### Planning Commission

Wednesday, September 21, 2022

**TECHNICAL REVIEW PLAT REQUIREMENTS  
REGULAR PLANNING COMMISSION MEETING  
September 21, 2022**

Submitted: 03/30/22  
 SCALE: 1"=100'  
 JOB NO.: 42878.C1.01  
 SHEET: 1 of 1  
 DRAWN BY: JAB  
 ©2022 by Urban Engineering  
 urbansurvey1@urbaneng.com

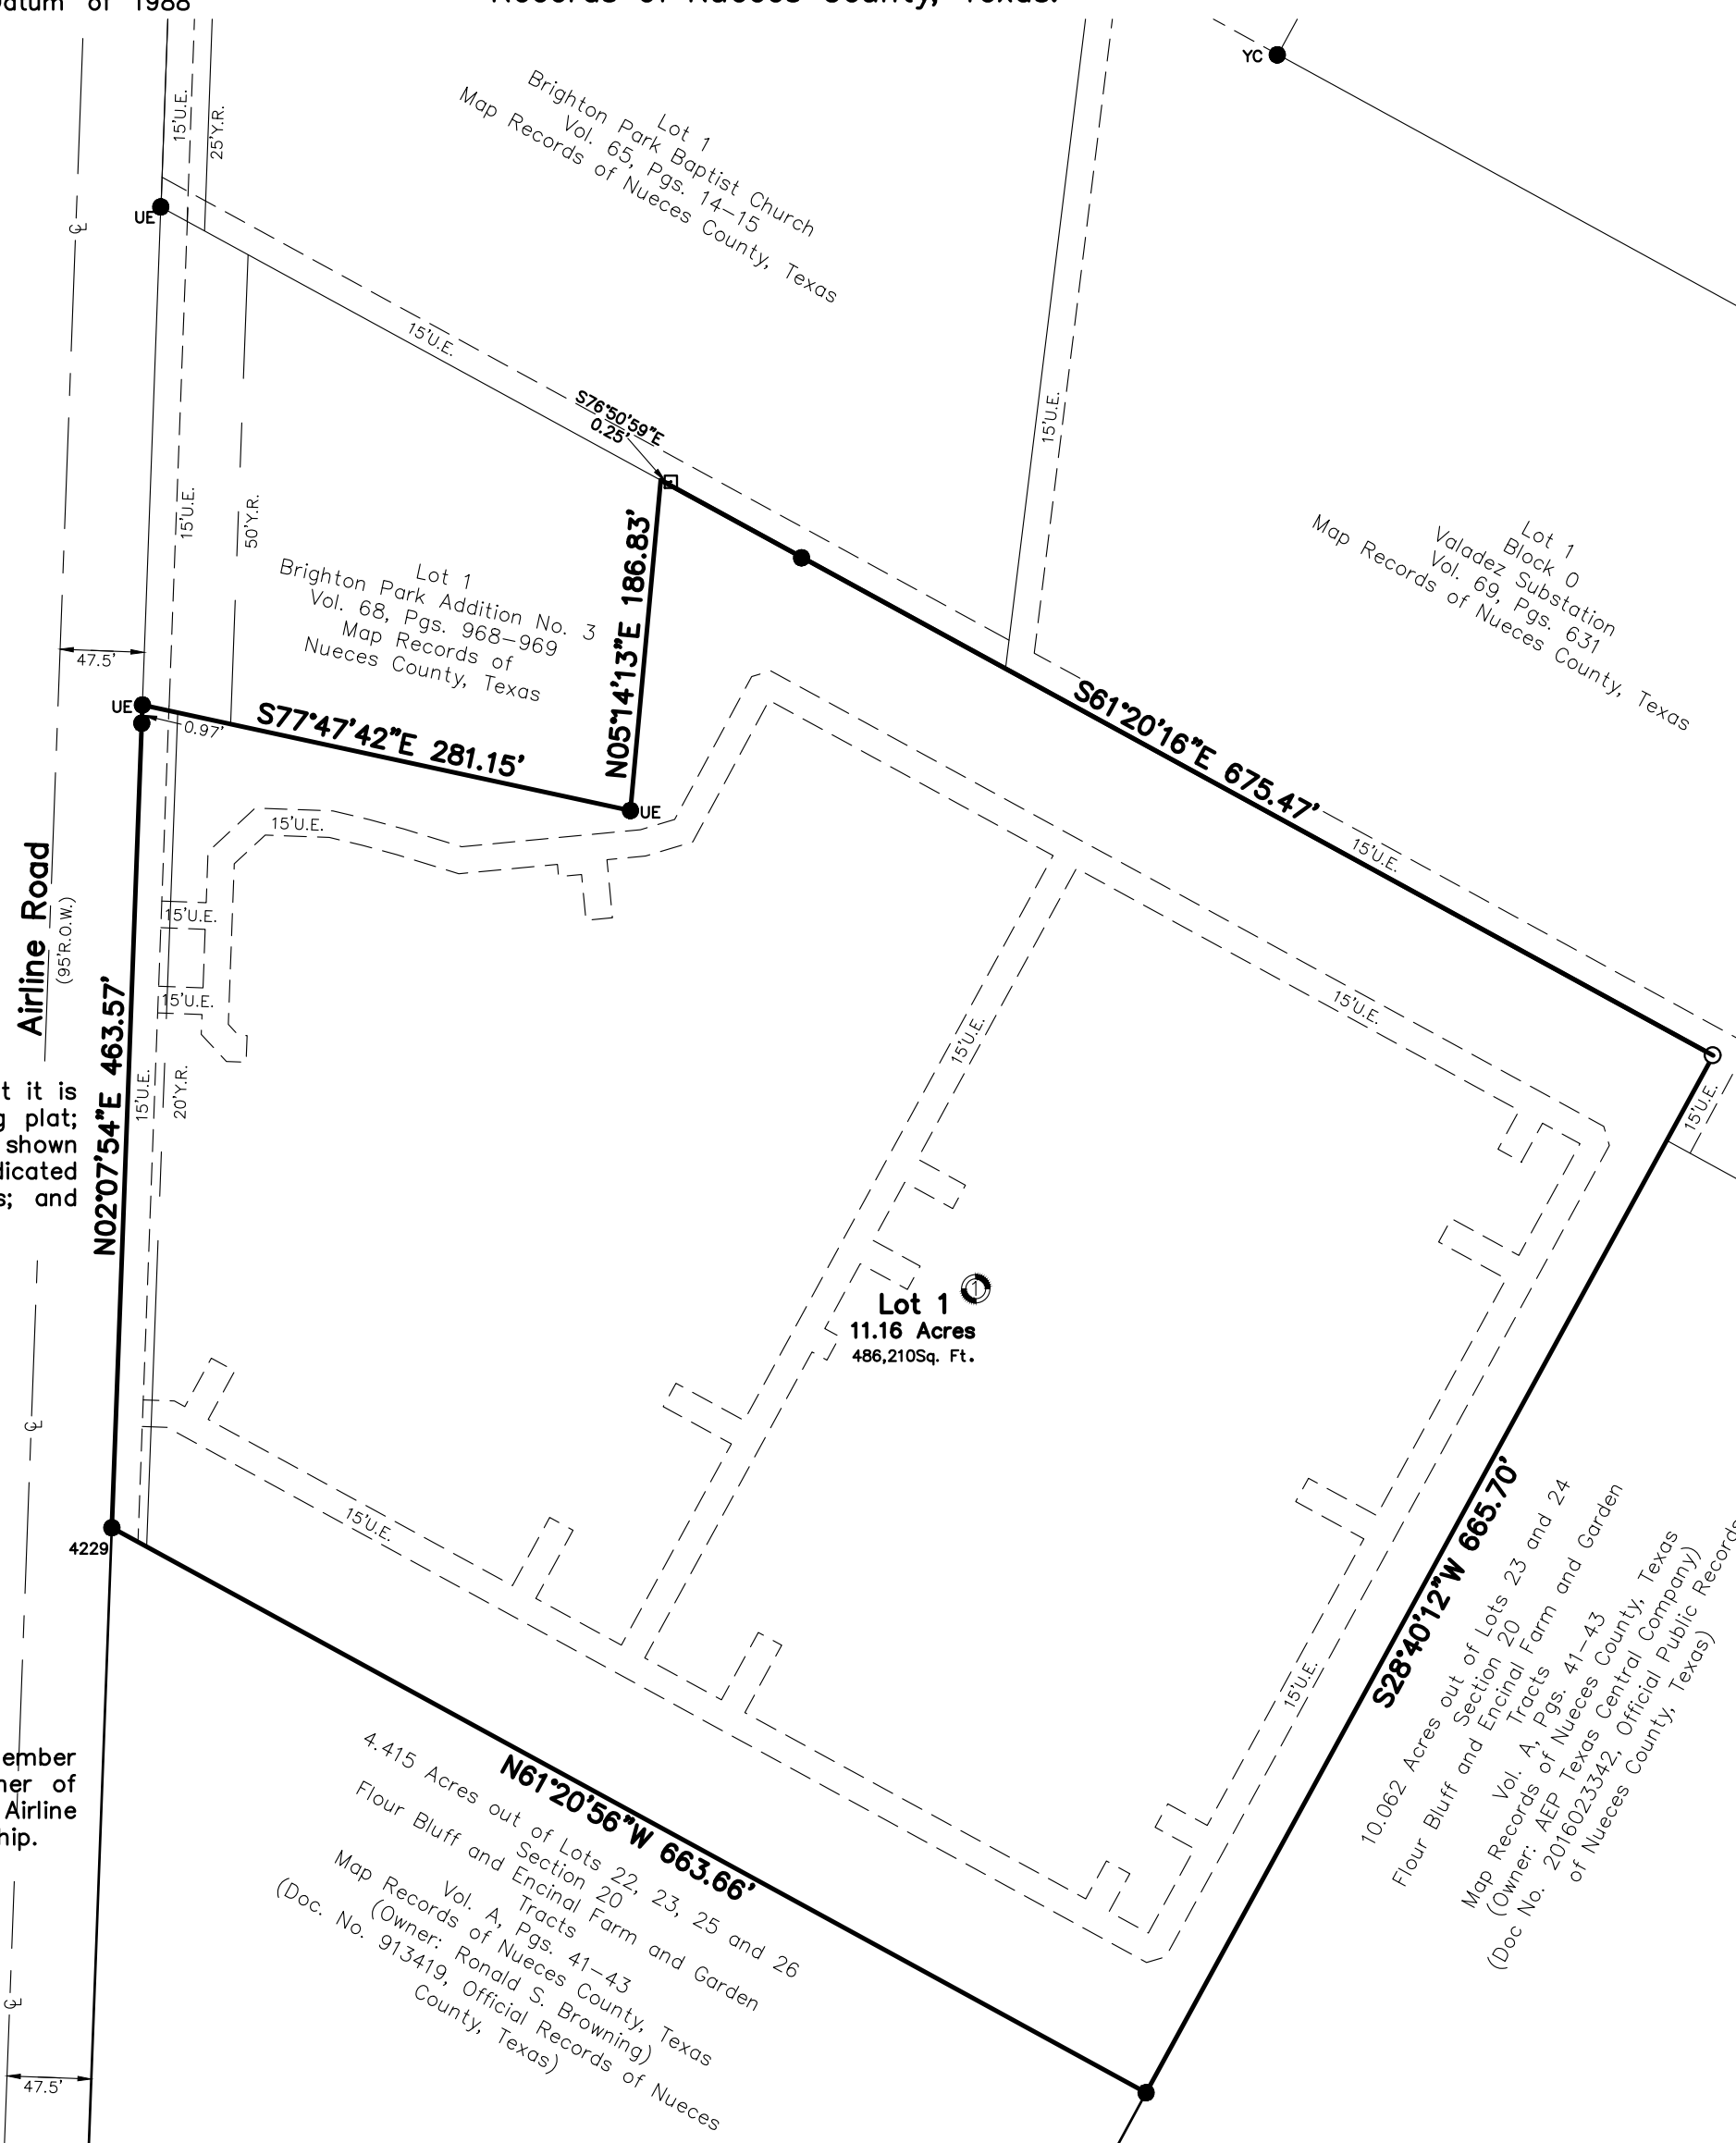
GIS						
No.	Sheet	Comment	Applicant Response	Staff Resolution	Applicant Response	Staff Resolution
1	Plat	Plat closes to acceptable engineering standards. (TSPS Manual of Practice Appendix A, Condition 3; Suburban Traverse Error of Closure)	Understood

LAND DEVELOPMENT						
No.	Sheet	Comment	Applicant Response	Staff Resolution	Applicant Response	Staff Resolution
1	Plat	Prior to plat recordation remove the reference "Preliminary, this document shall not be recorded..."	Understood			
2	Plat	Water Distribution Acreage fee - 11.16 acre x \$1,582.90/acre = <b>\$17,665.16</b>	Understood	Prior to plat recordation		
3	Plat	Wastewater Distribution Acreage fee - 11.16 acre x \$1,728.10/acre = <b>\$19,285.60</b>	Understood	Prior to plat recordation		
4	Plat	Water Pro-Rata - 463.57 LF x \$11.58/LF = <b>\$5,368.14</b>	Understood	Prior to plat recordation

No.	Sheet	Comment	Applicant Response	Staff Resolution	Applicant Response	Staff Resolution
1	Plat	Development on this site shall manage storm water drainage caused by the development of the property, drainage directed to the property by ultimate development, and drainage naturally flowing onto and through the property per UDC 8.2.8.B.2	Understood	Addressed		
2	Public Improvement Plans	Public Improvements Plans are required; submit a pdf copy of proposed public improvements along with a title sheet to PublicImprovements@cctexas.com for review and approval; this item is required prior to Final Plat Recordation. UDC 8.1.3.A	Public Improvement plans have been submitted on 7/15/22 for review	Addressed		
3	Utilities	Design information to be provided with Final Plat / Public Improvement plans. City may request additional information, as deemed necessary for future reviews and approvals.	Understood	Addressed

4	Utilities	Indicate location of proposed connection to existing utilities	Connection points for proposed utilities has been added	Addressed		
5	Utilities	Show utilities on the west side of Airline Drive, and wastewater lines to the north of the property.	Utilities have been added	Addressed		
6	SWQMP	Provide a brief description of the Project to include current land use, proposed land use, soil types on site, existing drainage structures and patterns on or near the site and proposed drainage patterns and structures and to be constructed with the development. (MC14-1002)	Project description has been added to the SWQMP	Addressed		
7	SWQMP	Confirm that rainfall intensity and run-off calculation coefficients are consistent with the Current Infrastructure Design Manual. Cite the source of the information.	Intensities, coefficients and sources have been listed on th SWQMP	Addressed		
8	SWQMP	Delineate the path and ultimate outfall of runoff to the receiving waters. (MC 14-1002)	Detention pond outfall pipes and flow direction arrows have been added to the SWQMP.	The ultimate outfall is the the body of water where the water will ultimately drain. You stated on Note 2 is the Oso Bay. In the diagram on the top righ an arrow line needs to be drawn to indicate the drainage path from the development to the Oso Bay	information has been added to location map	Addressed

9	SWQMP	Provide Estimated runoff at connections to existing systems	Connection points for storm water to existing system has been called out and flows calculated.	Addressed		
10	SWQMP	Provide contours or flow direction arrows to document pre-, and post-Development flow pattens (on and off site). And state how off-site flow contributions are to be managed. (MC - 1002, 1003, UDC 8.2.8.B)	Flow arrows have been added to the SWQMP. Statement has been added regarding off-site flow contributions.	Addressed		
11	SWQMP	Provide retention calculations and cross sections of the proposed retention structures.	Detention pond calculations have been added to the SWQMP.	Addressed		
12	SWQMP	show the location of retention pond outflows and how the flow is directed to existing stormwater systems.	Detention pond outfall pipes and flow direction arrows have been added to the SWQMP.	Addressed		
13	SWQMP	Verify capacity of the existing storm water systems and confirm conformance with the stormwater master plan or appropriate master plan amendment. (MC14-1002)	Capacity is sufficient. Drainage is consistent with 2011 HDR Airline Road Plans.	Addressed

Revised: 8/8/22  
Submitted: 6/22/22  
SCALE: 1"=100'  
JOB NO.: 42900.C2.01  
SHEET: 2 of 2  
DRAWN BY: XG

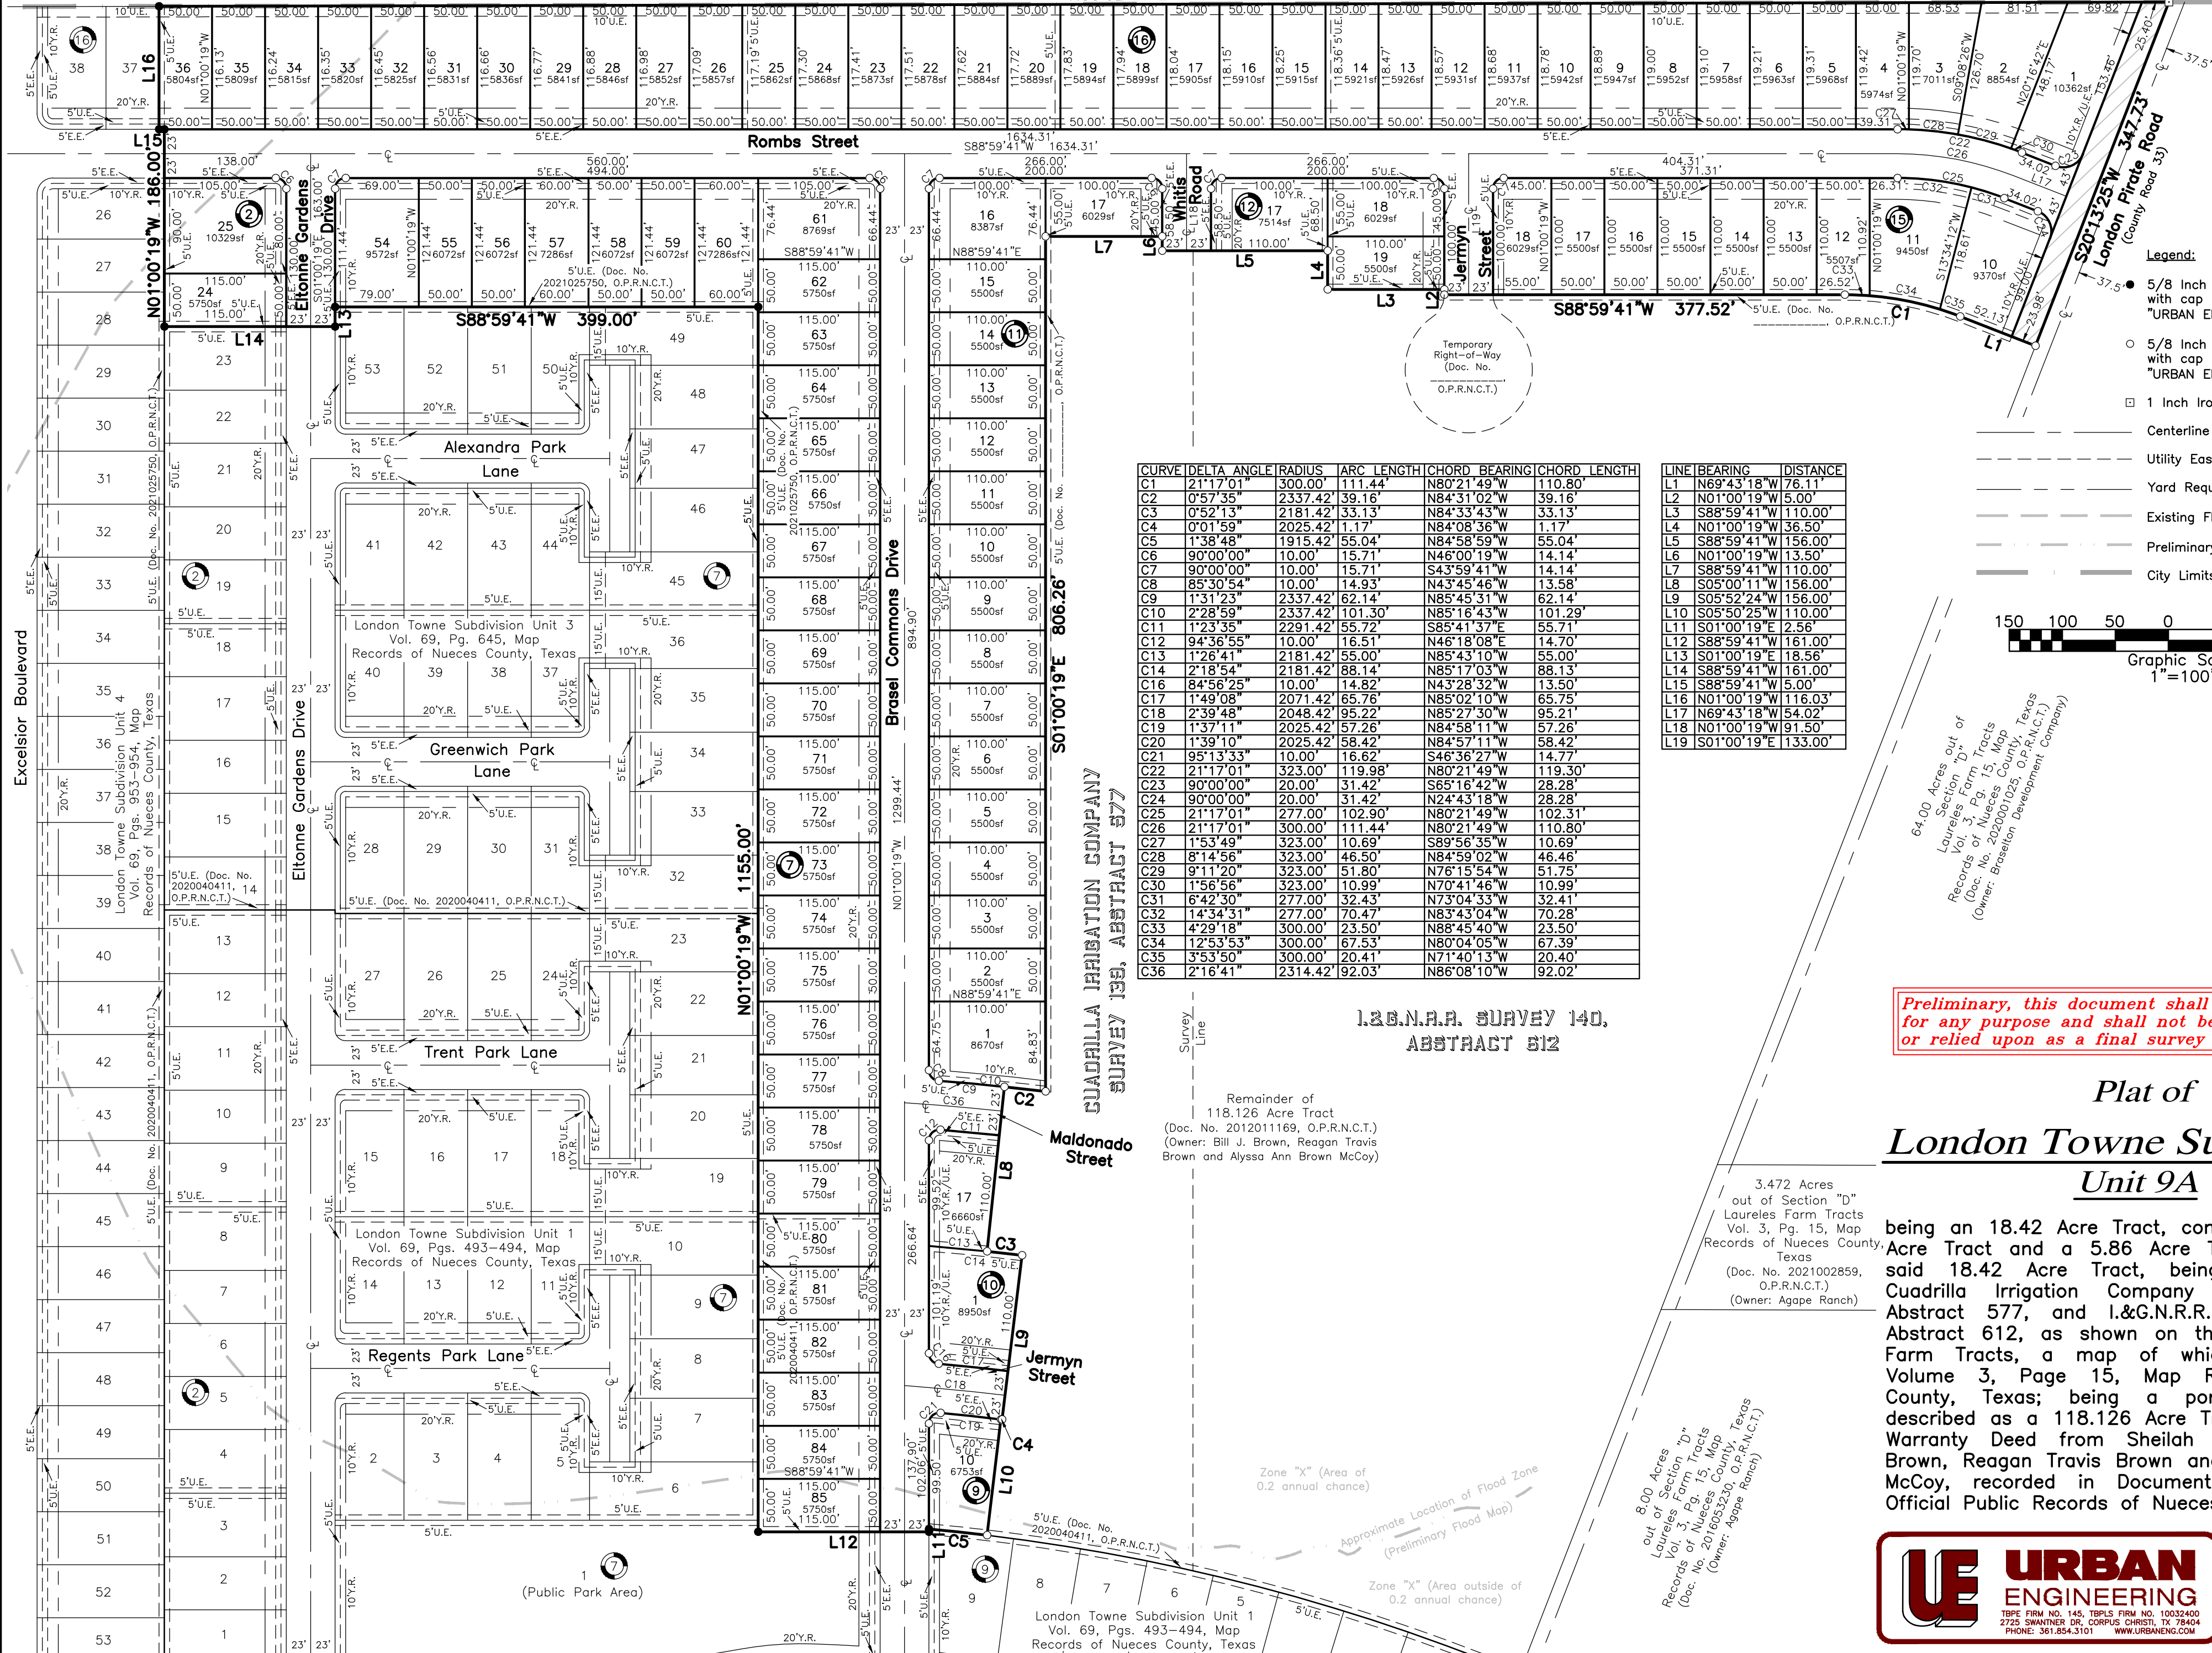
GIS						
No.	Sheet	Comment	Applicant Response	Staff Resolution	Applicant Response	Staff Resolution
1	Plat	Plat closes to acceptable engineering standards. (TSPS Manual of Practice Appendix A, Condition 3; Suburban Traverse Error of Closure)	Understood			
2	Plat	Street names Whitehall and Shaftsbury already exist. Pls revise with new proposed street names.	Street names have been revised	Resolved.

LAND DEVELOPMENT							
No.	Sheet	Comment	Applicant Response	Staff Resolution	Applicant Response	Staff Resolution	Applicant Response
1	Plat	Prior to plat recordation of London Towne Subdivision Unit 9A, will need to be consistent with the latest approved preliminary plat, including the phasing plan. (UDC 3.8.5.A) The final plat cannot be approved unless the final plat is consistent with the preliminary plat or the preliminary plat is revised and approved. <b>Submit the new revised Preliminary plat and Unit 9A concurrently, both plats will need to be scheduled to the next available Planning Commission Meeting.</b>	Final plat of Unit 9A is consistent with approved preliminary plat. All lots shown are identical to what was approved on the preliminary plat.	The unit layout is not addressed.	The final plat layout is identical (consistent) with the approved preliminary plat as required under Section 3.8.5.A.2. Phasing/Unit boundaries are not discussed under Section 3.8.5.A.2, therefore there is no conflict to resolve.	Provide a Preliminary Plat labeling Unit 9A and label the unit for remaining lots for Unit 9 (see attached 10-13-21 Approved Preliminary PC Plat)	We have revised the preliminary plat. See attached. DS Land Development Acknowledge: ADDRESSED

2	Plat	Remove General Note-#9 #10referencing public open space regulation.	Note 10 (not 9) has been removed.	Addressed			
3	Plat	Along Romba Street identify the dashlines for Block 7, Lot 61	Additional labels have been added	Addressed			
4	Plat	London Towne Subdivision Unit 4 will need to be filed and recorded prior to plat recordation of Unit 9A.	Understood	Prior to plat recordation			
5	Plat	Prior to recordation, show and label on the plat the recorded document number for Unit 4.	Information has been added	Prior to plat recordation

6	Plat	<b>Prior to recordation</b> , show the document number for <u>any</u> utility easements, temporary right-of-way easements and drainage easements dedicated by separate instrument.	Understood	Prior to plat recordation		
7	Plat	<b>Prior to plat recordation</b> provide new transfer warranty deed per Braselton Development Company, Ltd.	Understood	Prior to plat recordation		
8	Plat	<b>Prior to plat recordation</b> remove the reference "Preliminary, this document shall not be recorded..."	Understood	Prior to plat recordation		
9	Plat	<b>Prior to plat recordation</b> coordinate with your electrical provider on street light fees and provided confirmation of payment.	Understood	Prior to plat recordation		
10	Plat	Water Lot fee – 102 Lots x \$200.20/Lot = <b>\$20,420.40</b>	Understood	Prior to plat recordation		
11	Plat	Wastewater Lot fee – 102 Lots x \$432.30/Lot = <b>\$44,094.60</b>	Understood	Prior to plat recordation

GAS						
No.	Sheet	Comment	Applicant Response	Staff Resolution	Applicant Response	Staff Resolution
1	Plat	Provide 5' U.E. on lot 36, blk. 16 west side of lot and 5' U.E. on lot 85, blk. 7 south side of lot.	Easements have been added	Provide 5' U.E. in back of lot 18, blk. 12 south side of lot and change 10' Y.R. to 10' Y.R./U.E. on lot 10, blk. 15	Easements have been added	DS LD Acknowledge; Addressed
